**TOWN OF ESSEX
PLANNING COMMISSION
AGENDA
February 10, 2022-6:30 P.M.
MUNICIPAL CONFERENCE ROOM,
81 MAIN ST., ESSEX JCT., VT**

1. **Public Comments**
2. **FINAL PLAN-PUBLIC HEARING: Richard Jenny:** Proposal to create a 3-lot residential subdivision on a 33-acre vacant parcel located at 44 Brigham Hill Lane in the Conservation (C1) Zone. Tax Map 17, Parcel 3.
3. **CONCEPTUAL DISCUSSION: Scott A. Lee & Pamela P. Schirner:** Request to proceed with a 2-lot PUD application for property located at 247 River Road in the Industrial (I1) & Agricultural Residential (AR) Zones. Tax Map 33, Parcel 17.
4. **Minutes:** January 27, 2022
5. **Other Business**

3 **44 Brigham Hill Lane – Minor Subdivision (Final)**

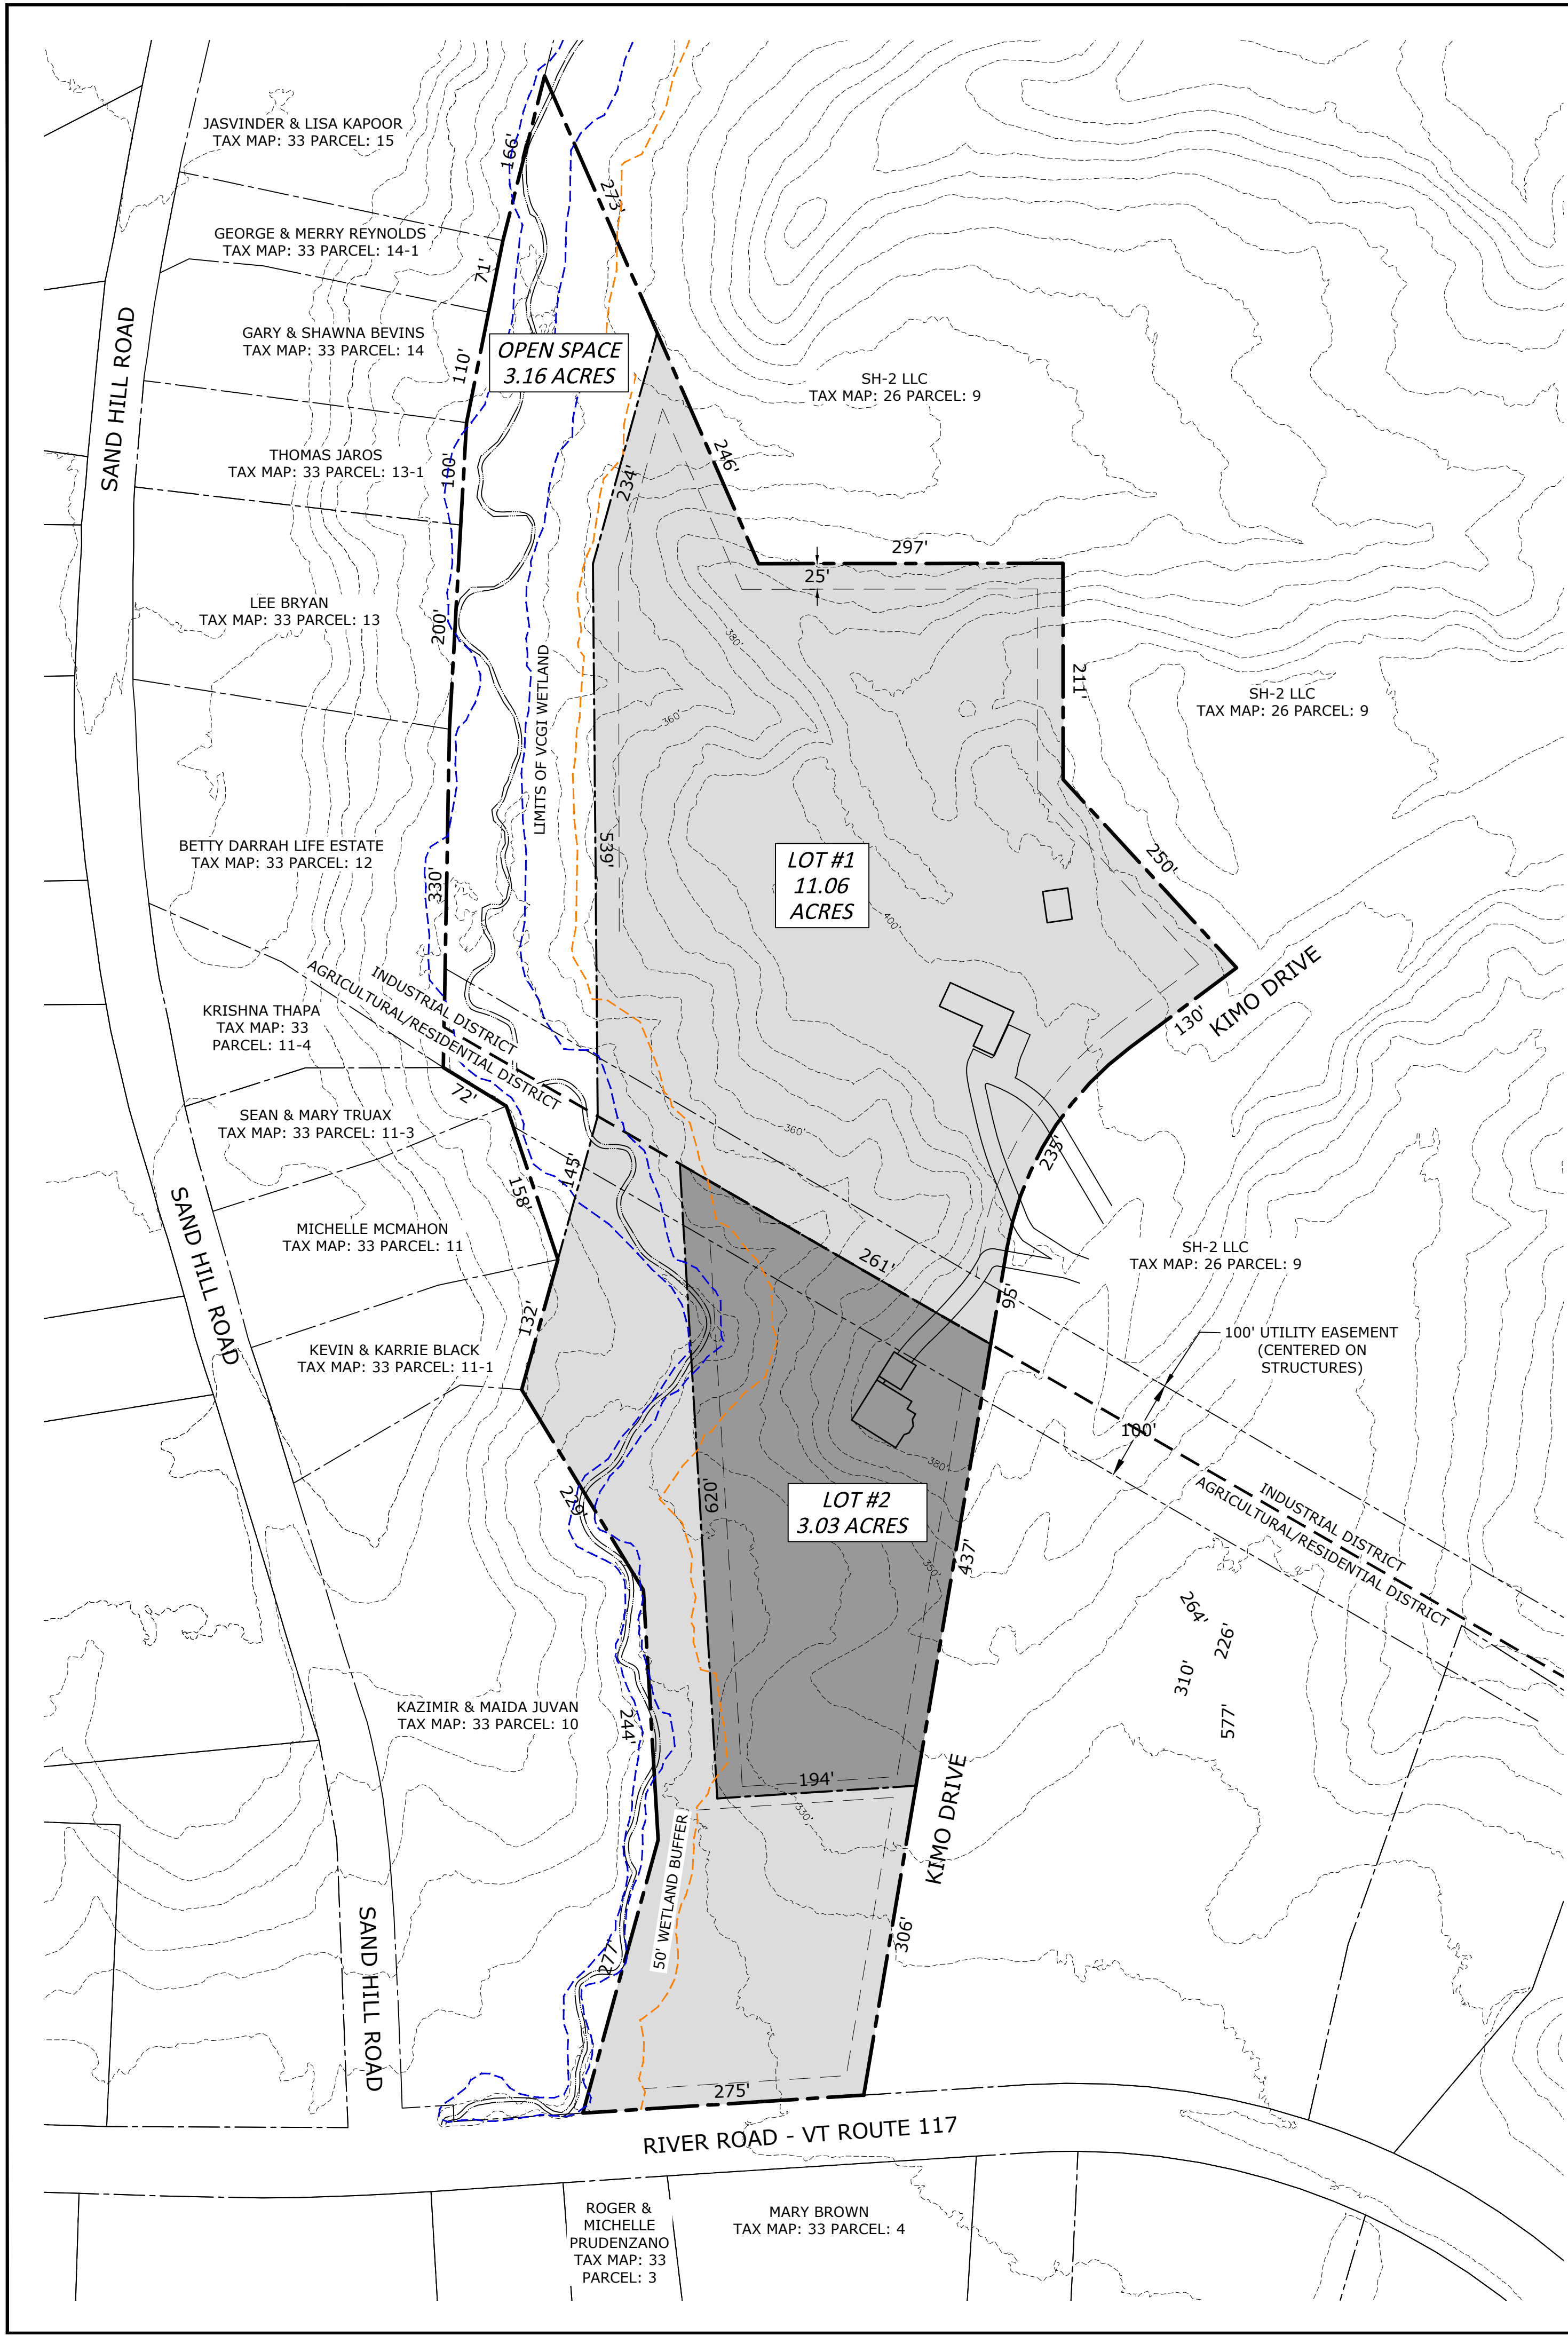
3. *Not knowing the potential uses for the portions of Lots 1 and 2 within the sewer core, how are the assigned EU's going to be distributed?*

(Engineer's Reply): As Lot 2 is outside of the sewer core, it will not have any allocated EU's. The 3 EU's already associated with the land inside the I1 district/sewer core, in our opinion, should stay with Lot 1.

As a result of the answers, in an email dated 2/3/2022, PW's replied, *The updated draft plan addresses the concerns Public Works had with the initial submittal. Further comment will be provided at future submittals.*
